## Windshield washer system spray nozzle on engine hood loose

Topic number	LI82.35-P-063732
Version	1
Design group	82.35 Windshield washing system
Date	03-28-2016
Validity	253, 213
Reason for change	
Reason for block

Bild2.jpg:

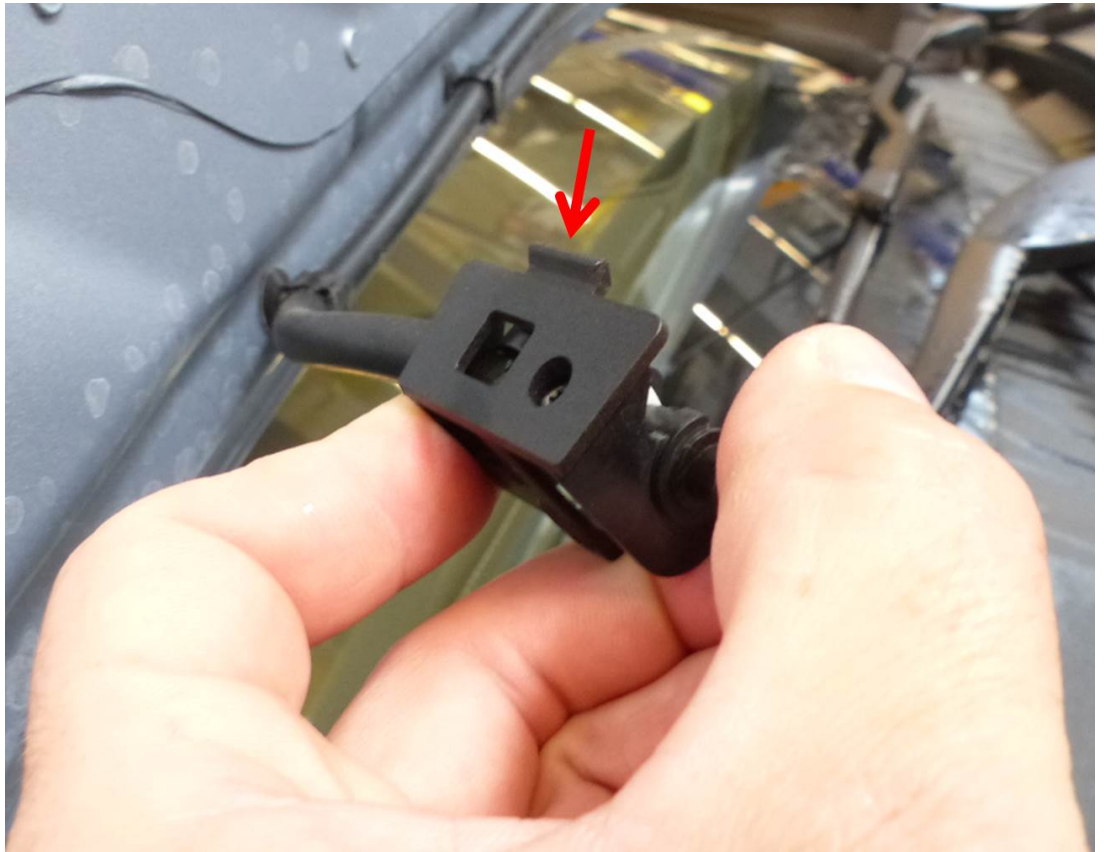
Windshield washer system spray nozzle on engine hood loose (Figure 1)

Tolerance for mounting holes in engine hood

Apply adhesive pad onto long catch tab of spray nozzle (Figures 2 and 3)

Attachments	
File	Description
Bild2.jpg	Position of adhesive pad on long catch tab of spray nozzle
Bild3.jpg	Spray nozzle with adhesive pad attached
